**The Great Grid Upgrade**

Norwich to Tilbury

2022 Non-statutory Consultation Feedback Report

June 2023

Figure 3.16 - South Norfolk section map

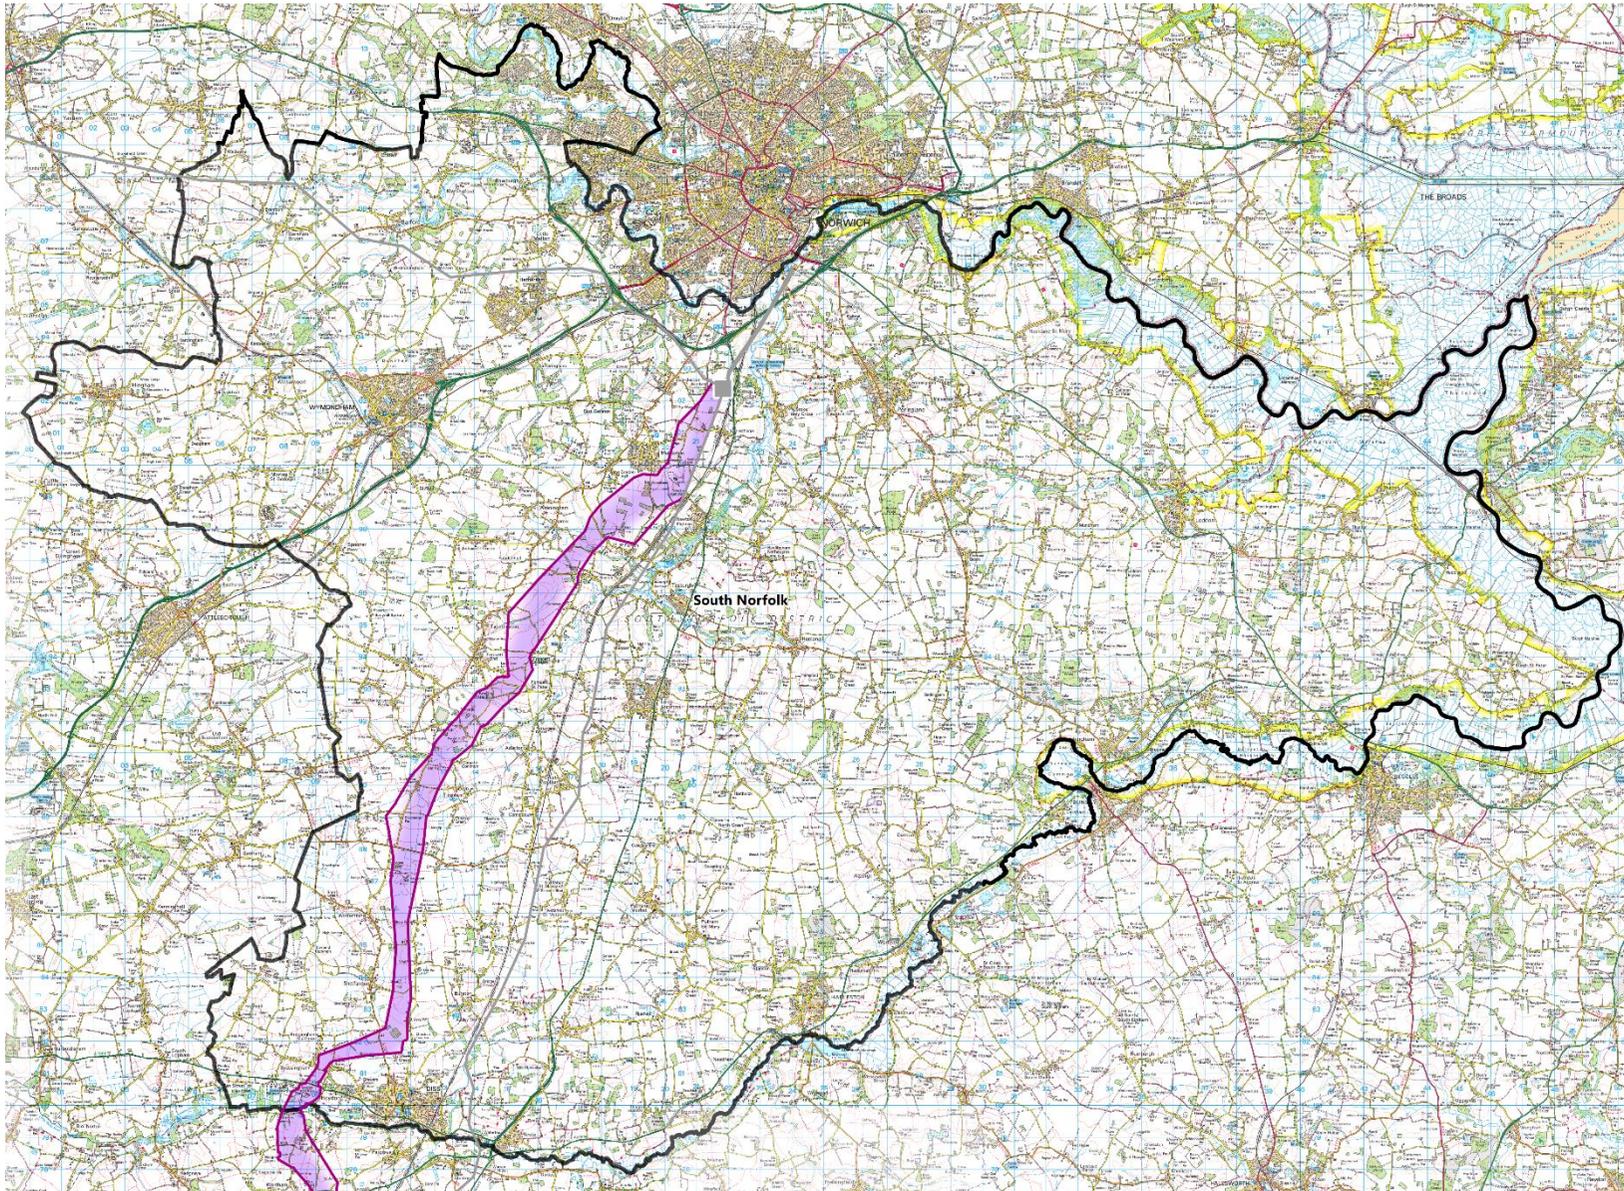
Ref no.	Summary of matters raised	National Grid's response
Community / Social impact		
3.3.1	Concerned about impact of the Project on children / families / residents	<p>National Grid recognises people may have concerns about the potential impacts of living close to an overhead line, and that the uncertainty whilst the proposals are developed may cause some stress and anxiety.</p> <p>We have sought to reduce potential effects on communities and residents through routing and design including ensuring compliance with UK guidance on Electric and Magnetic Fields (EMF). We have also sought to reduce concern or uncertainty about the proposals through making timely design decisions and engaging with the people and stakeholders throughout the development of the Project.</p> <p>The Project team will continue to engage with people potentially affected during the development of the Project, through regular communication including letters, phone calls and meetings. This will enable concerns to be raised and discussed at an early opportunity and provide a regular point of contact to respond to queries and concerns. We urge anyone with concerns to get in touch through the Norwich to Tilbury Freephone number, address or email throughout the development of the Project:</p> <ul style="list-style-type: none"> <li>• <b>Call our Community Helpline: 0800 151 0992</b> (Lines are open Monday to Friday 9:00am – 5:30pm)</li> <li>• <b>Email us: <a href="mailto:contact@n-t.nationalgrid.com">contact@n-t.nationalgrid.com</a></b></li> <li>• <b>Write to us: FREEPOST N TO T</b> (No stamp or further address details are required)</li> </ul>

Figure 3.17- Mid Suffolk section map

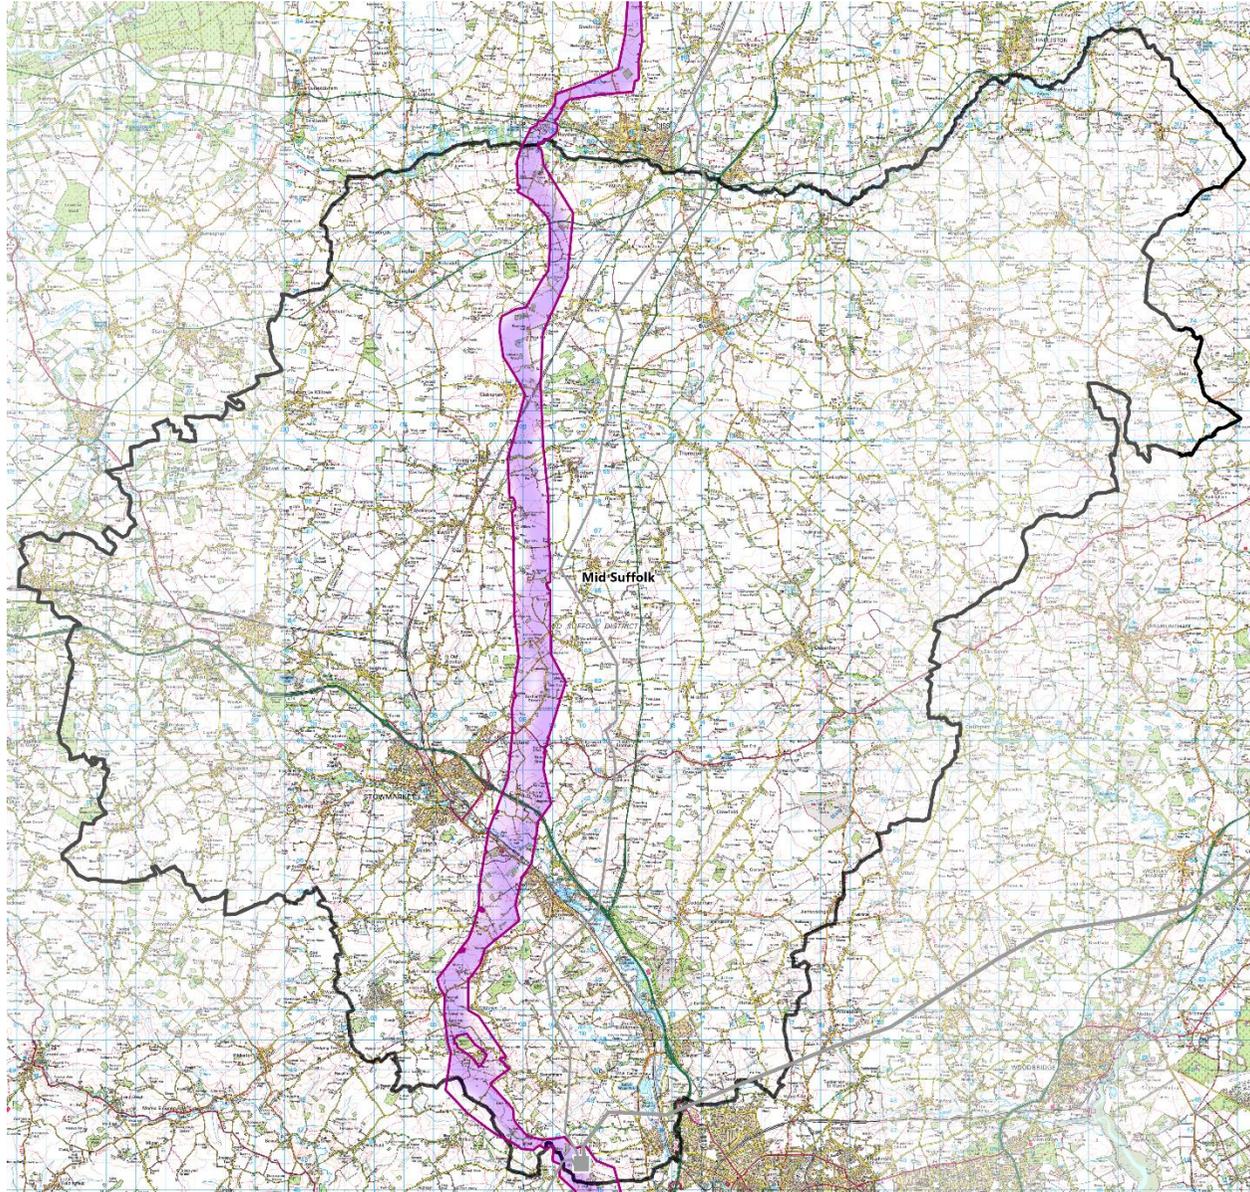
Ref no.	Summary of matters raised	National Grid's response
Agricultural land		
3.4.1	The Project will be taking away valuable agricultural land / disrupt farming operations	National Grid recognises that there is the potential for impacts. We look to limit the impact on agricultural land through careful and considered routeing and siting of infrastructure and through consultation with affected landowners. We are and will continue to work with all landowners including farmers who may be affected by the proposals to understand the potential impacts on their operations and to work with them as the Project is developed. We will seek to work with the farming community to limit disruption where practicable. This includes providing prior warning of works which may result in the need to move livestock. Compensation claims for disturbance are considered on a case-by-case basis. . Particular agricultural matters can also be written into voluntary land agreements.

Figure 3.18- Babergh, Tendring and Colchester section map

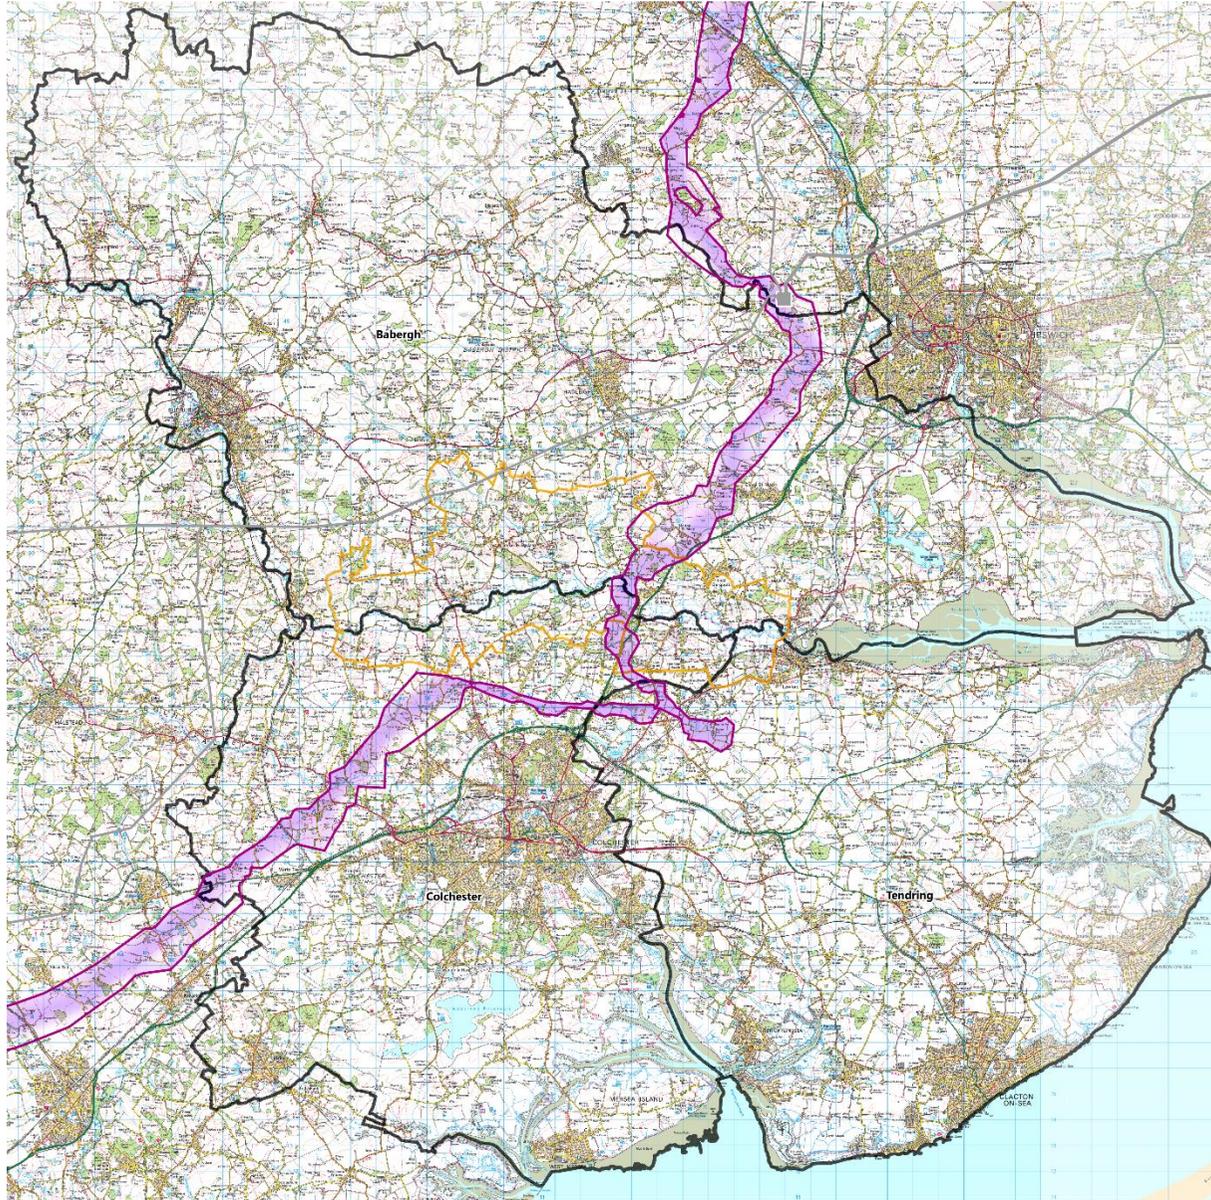
Ref no.	Summary of matters raised	National Grid's response
Agricultural land		
3.5.1	The Project will be taking away valuable agricultural land / disrupt farming operations	National Grid recognises that there is the potential for impacts. We look to limit the impact on agricultural land through careful and considered routeing and siting of infrastructure and through consultation with affected landowners. We are and will continue to work with all landowners including farmers who may be affected by the proposals to understand the potential impacts on their operations and to work with them as the Project is developed. We will seek to work with the farming community to limit disruption where practicable. This includes providing prior warning of works which may result in the need to move livestock. Compensation claims for disturbance are considered on a case-by-case basis. Particular agricultural matters can also be written into voluntary land agreements.

Figure 3.19- Braintree section map

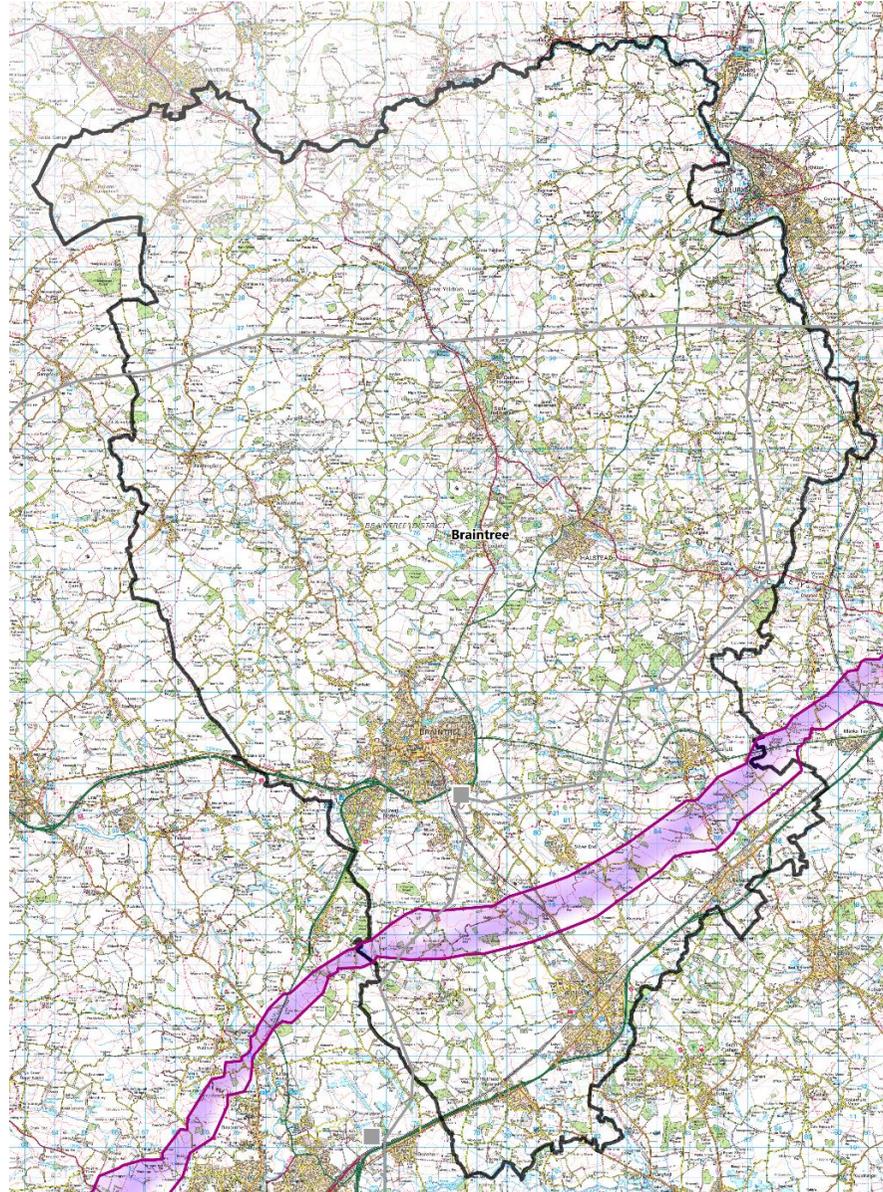
Ref no.	Summary of matters raised	National Grid's response
Agricultural land		
3.6.1	The Project will be taking away valuable agricultural land / disrupt farming operations	National Grid recognises that there is the potential for impacts. We look to limit the impact on agricultural land through careful and considered routeing and siting of infrastructure and through consultation with affected landowners. We are and will continue to work with all landowners including farmers who may be affected by the proposals to understand the potential impacts on their operations and to work with them as the Project is developed. We will seek to work with the farming community to limit disruption where practicable. This includes providing prior warning of works which may result in the need to move livestock. Compensation claims for disturbance are considered on a case-by-case basis. Particular agricultural matters can also be written into voluntary land agreements.

Figure 3.20- Chelmsford section map

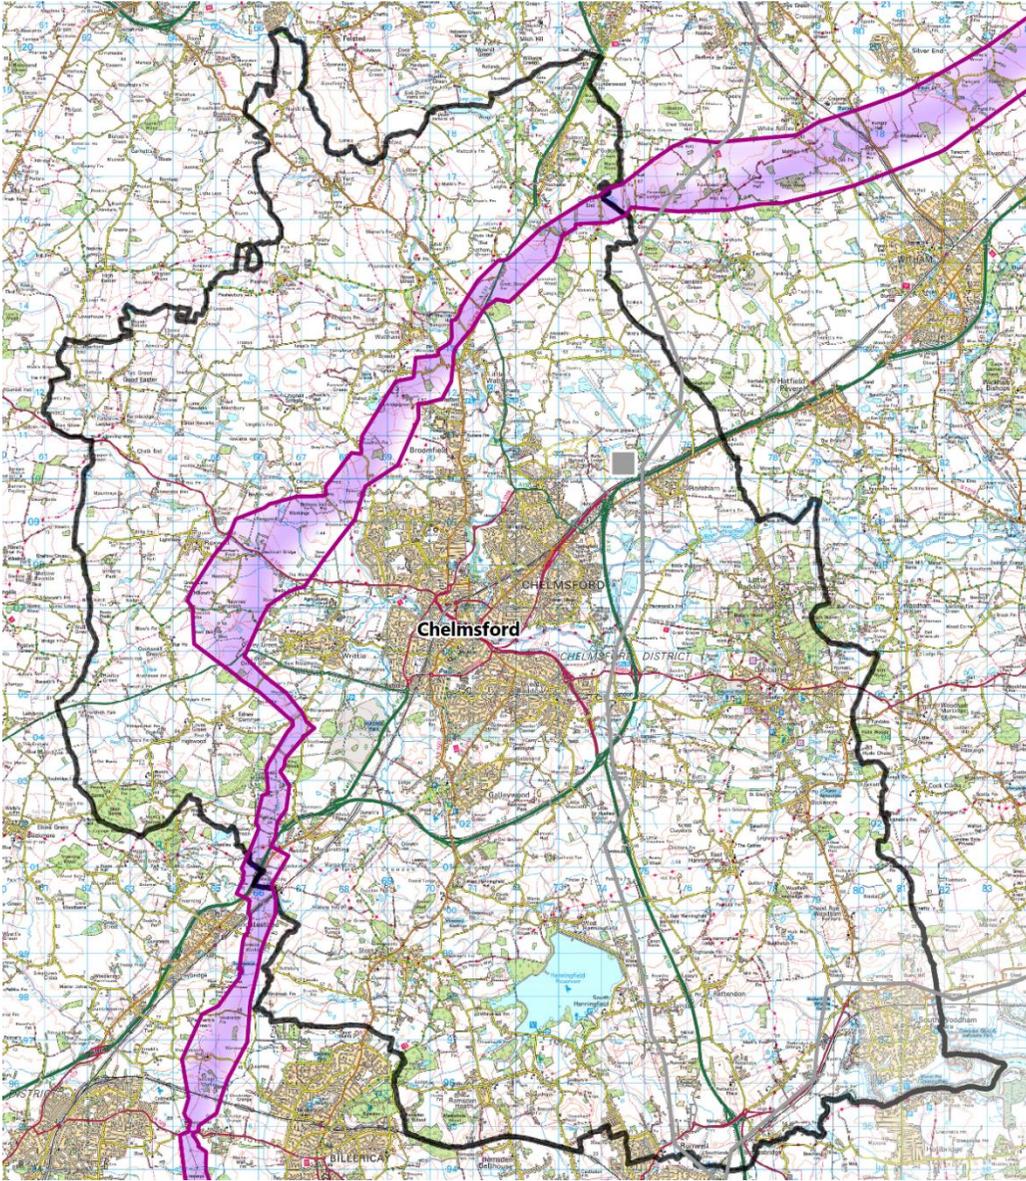
Ref no.	Summary of matters raised	National Grid's response
Agricultural land		
3.7.1	The Project will be taking away valuable agricultural land / disrupt farming operations	National Grid recognises that there is the potential for impacts. We look to limit the impact on agricultural land through careful and considered routeing and siting of infrastructure and through consultation with affected landowners. We are and will continue to work with all landowners including farmers who may be affected by the proposals to understand the potential impacts on their operations and to work with them as the Project is developed. We will seek to work with the farming community to limit disruption where practicable. This includes providing prior warning of works which may result in the need to move livestock. Compensation claims for disturbance are considered on a case-by-case basis. Particular agricultural matters can also be written into voluntary land agreements.

Figure 3.21- Basildon and Brentwood section map

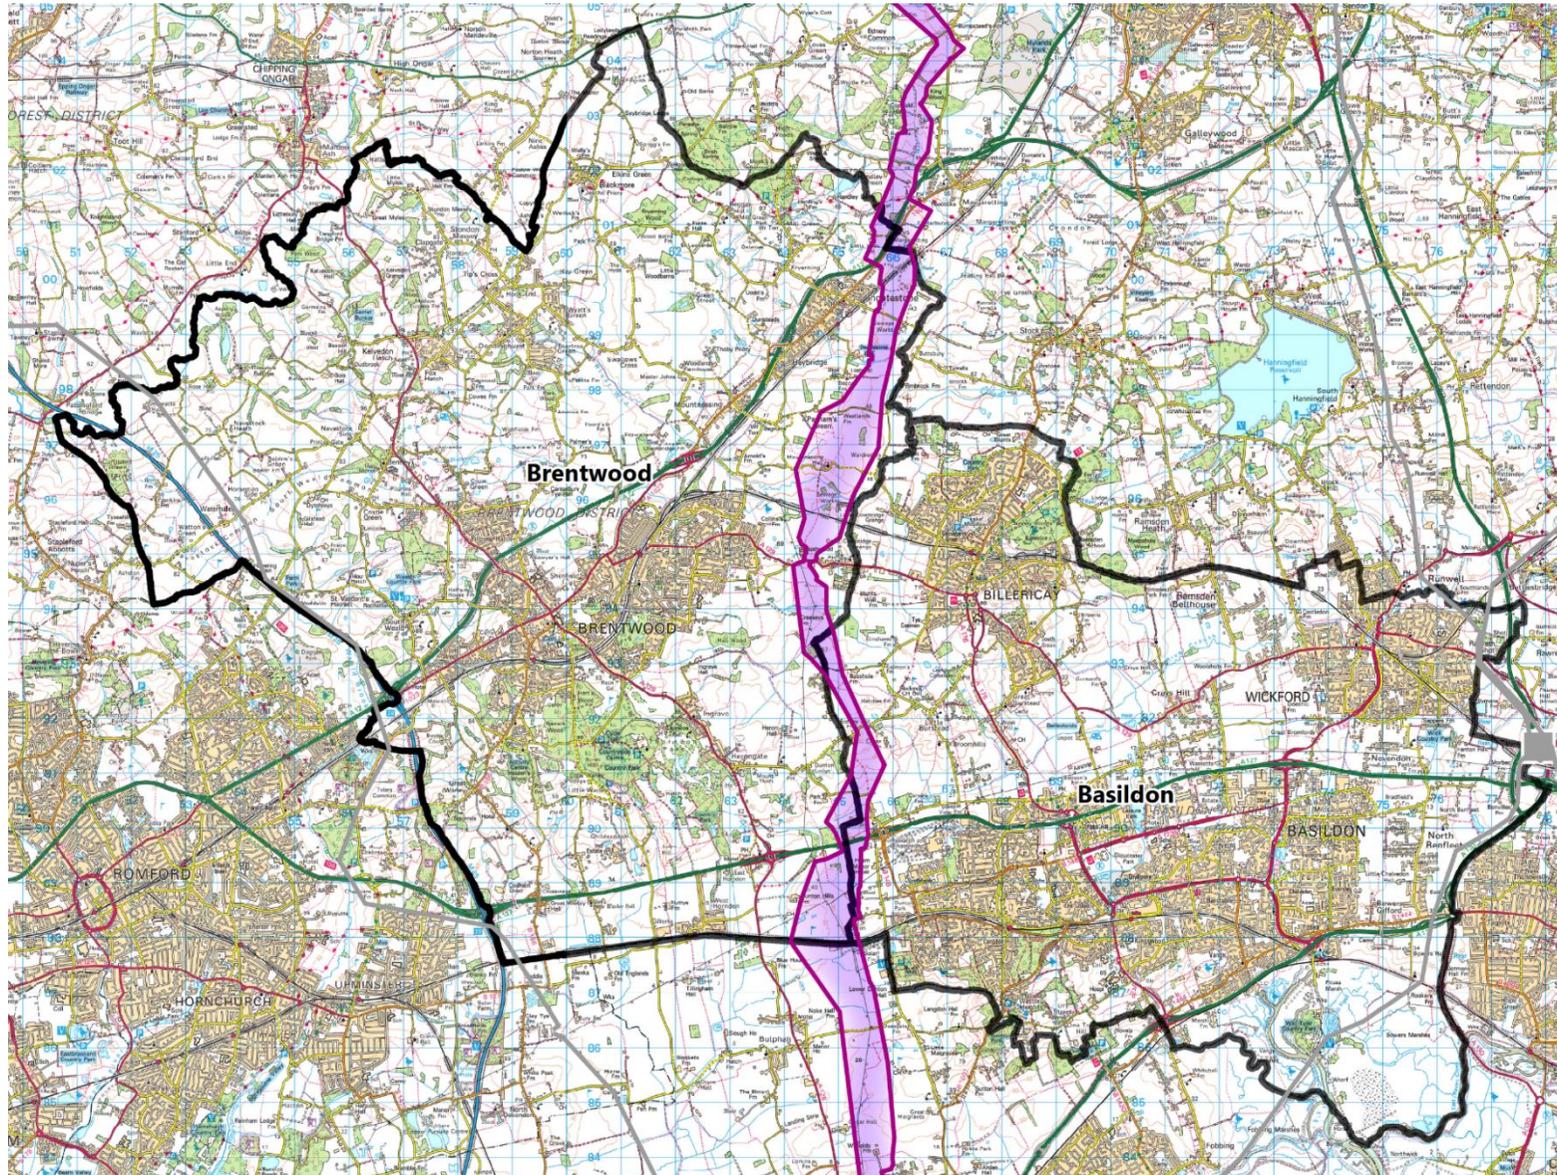
Ref no.	Summary of matters raised	National Grid's response
Agricultural land		
3.8.1	The Project will be taking away valuable agricultural land / disrupt farming operations	National Grid recognises that there is the potential for impacts. We look to limit the impact on agricultural land through careful and considered routeing and siting of infrastructure and through consultation with affected landowners. We are and will continue to work with all landowners including farmers who may be affected by the proposals to understand the potential impacts on their operations and to work with them as the Project is developed. We will seek to work with the farming community to limit disruption where practicable. This includes providing prior warning of works which may result in the need to move livestock. Compensation claims for disturbance are considered on a case-by-case basis. Particular agricultural matters can also be written into voluntary land agreements.
